JOB NAME: Kronenwetter Well

CHANGE ORDER NUMBER: ES-06

DESCRIPTION: Well Pump Rebuild Extras

Village of Kronenwetter Breakdown of Rohde Proposal #19539 Proposal Name: Kronenwetter Well #2

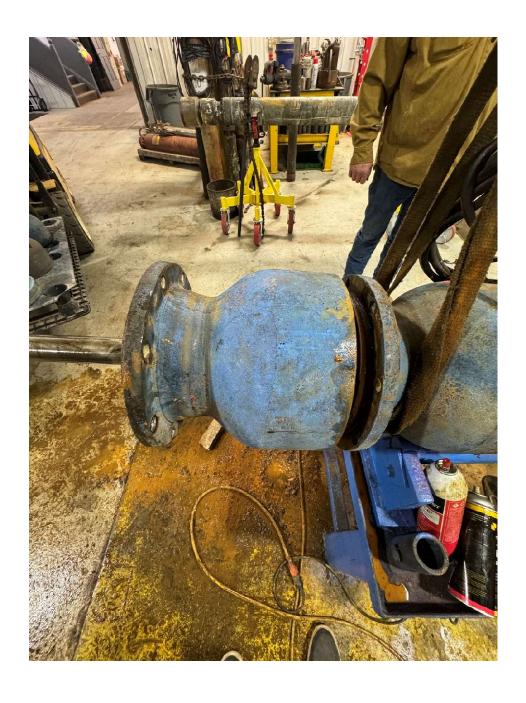
Top Side of Intermediate Pump Casting that was stuck on the pump shaft due to build up and sediment.

Side of Intermediate that was seized to the shaft and would not allow us to remove it any further in the picture without the extra measures we went through to not risk damaging or breaking the flange face of the casting.

Bottom Side Skirt of the impeller with debris and wear that would not allow for standard removal leading to extra time and measures to salvage and re-use.

Picture between intermediates showing wear on impeller skirt.

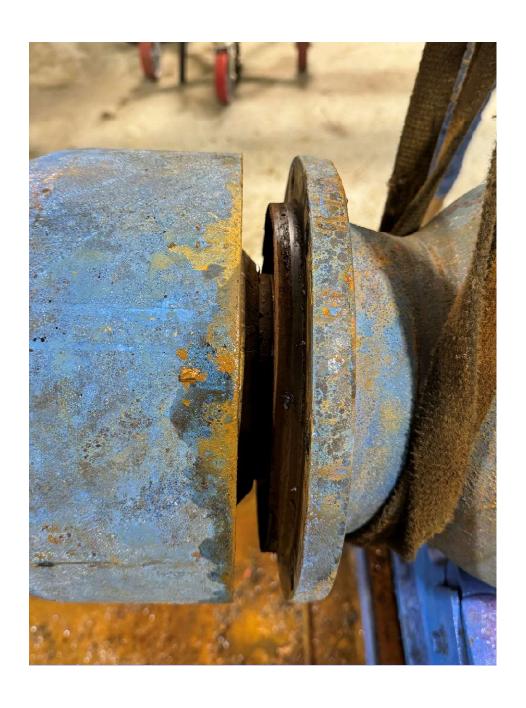
Side View Close up of intermediate and impeller stuck on shaft as pictured previously.

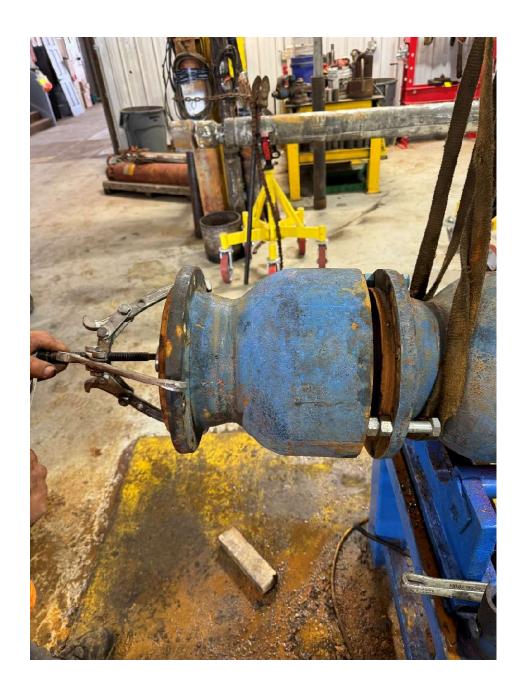
Top of Intermediate once the stuck intermediate and impeller were removed after all the additional efforts were made and successful in removing them with no damage to the pump. As you can see, there is a large amount of build up and sediment that were mainly the cause of the intermediate not coming off the shaft in a routine and easy fashion.

The stuck intermediate bearings were broken free by cutting the top of the bowl shaft off and using a 3-arm gear puller attached to the outside of the bowl casting with bolts and nuts on the backside to inch the bowl forward off the shaft without damaging it. I attached some pictures for visual. This is a very time-consuming process to not crack or damage the bowl casting. Once the bowl was free, we had to repeat these steps of cutting the shaft with the stuck bearing off to continue removing stages if the pump. All components were then pressure washed, and the bearings pushed out and replaced in each stage of the pump. A new bowl shaft was made, collets cleaned and re-assembled with the added stage and new ss bolting. The discharge case and the new stage had to be put in the lathe and re-faced to ensure a machined fit surface. The bowl was then painted and build completed.
